# New York State Department of Environmental Conservation

This letter contains the comments of New York State on the reports provided to the panel performing the peer review of the Phase 1 dredging work done as part of the remedial action at the Hudson River PCBs Federal Superfund Site. The reports were reviewed by the New York State Department of Environmental Conservation and Department of Health, along with the New York State Canal Corporation. The Canal Corporation will be providing comments in a separate letter.

Comment to the Peer Review Panel for Phase 1 of the Hudson River PCB Superfund Site  
New York State Department of Environmental Conservation  
Division of Fish, Wildlife and Marine Resources  
Wayne Richter, Research Scientist 3  
26 April 2010

Figure 1: Pumpkinseed long term series, lipid adjusted PCB. Large dots are annual means, small circles are individual values.

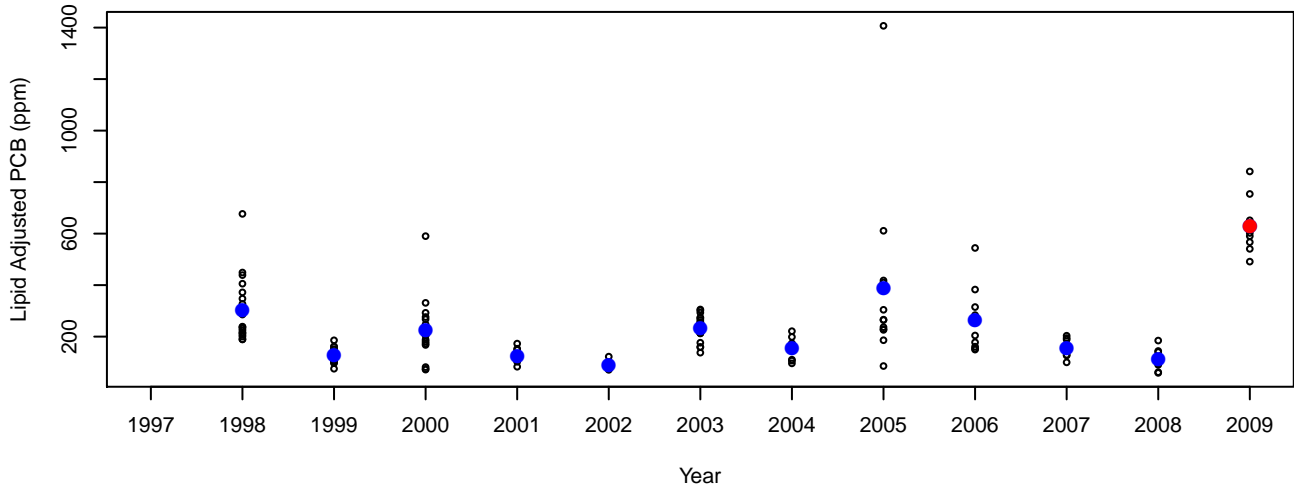
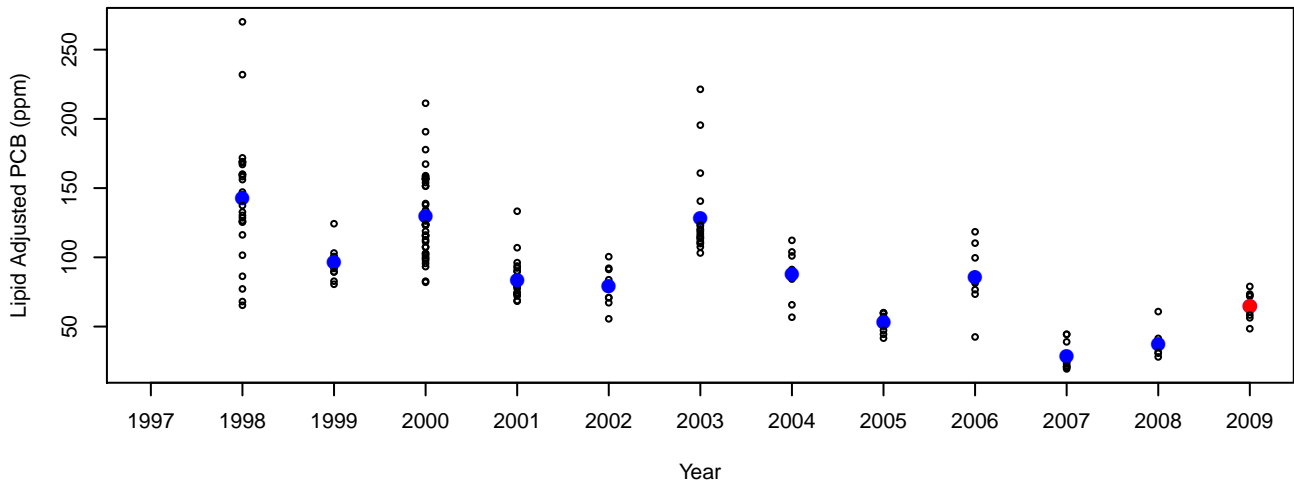
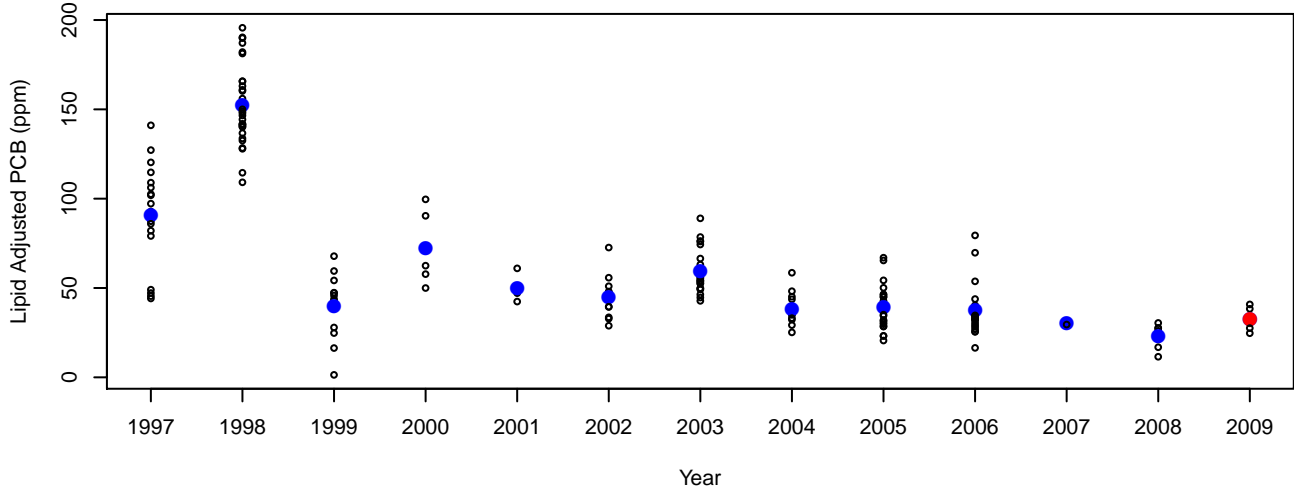
GE's claim of a decline between 2004 and 2008 also needs to be evaluated in the context of the available longer term data series. These show (Figure 1) only weak indications of a long term trend since about 1999 but considerable fluctuation from year to year with some tendency to a cyclical pattern.

Figure 3: Feeder Dam forage fish lipid adjusted PCB (annual median).

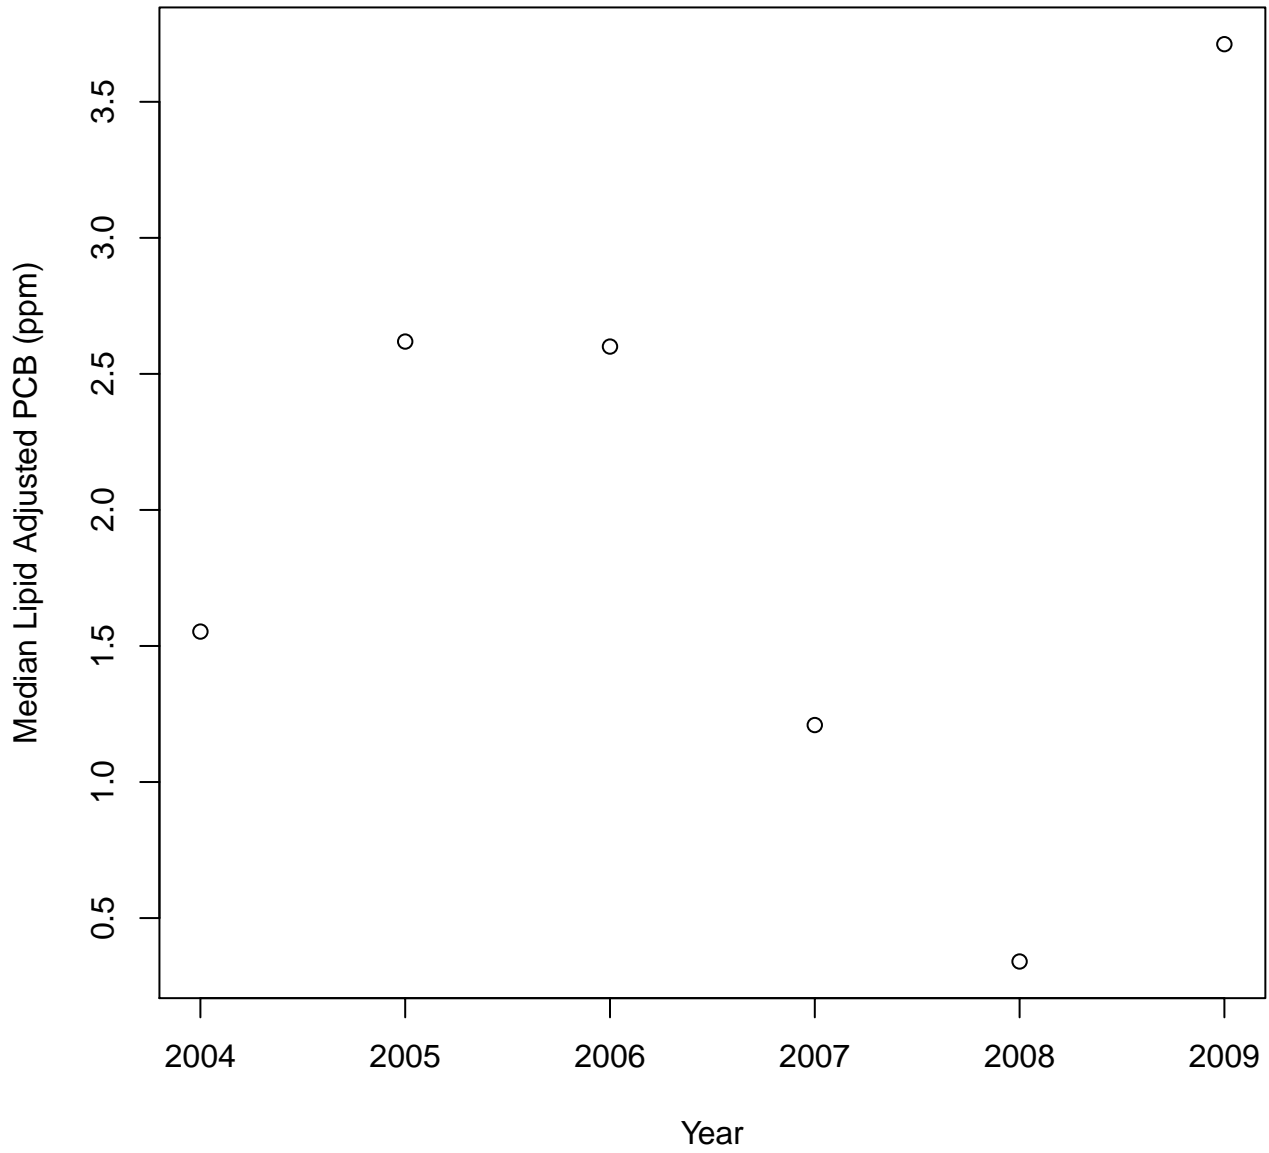
Also instructive is a comparison with the results from the Feeder Dam pool, the reference site on the Hudson River upstream of General Electric’s Hudson Falls and Fort Edward plants. The dominant temporal pattern in all four sections at or downstream from dredging was three years of relatively high PCB levels, followed by two lower years, followed by an increase in 2009 (GE figures 3.3-23a and 3.3-23b). This pattern was closely followed by the median (medians are used because many fish were reported as below the detection limit) PCB levels in forage fish at the Feeder Dam, although at considerably lower levels (Figure 2). Although this pattern was not seen in Feeder Dam pumpkinseeds, its presence in even one of the two reference species groups suggests that some of the 2009 rise in PCB levels in fish downstream of the dredging may be due to phenomena other than dredging such as regional hydrological or weather patterns. It is further worth noting that the median lipid adjusted PCB in pumpkinseeds at the Feeder Dam increased over fourfold between 2008 and 2009 from 0.41 ppm to 1.91 ppm.
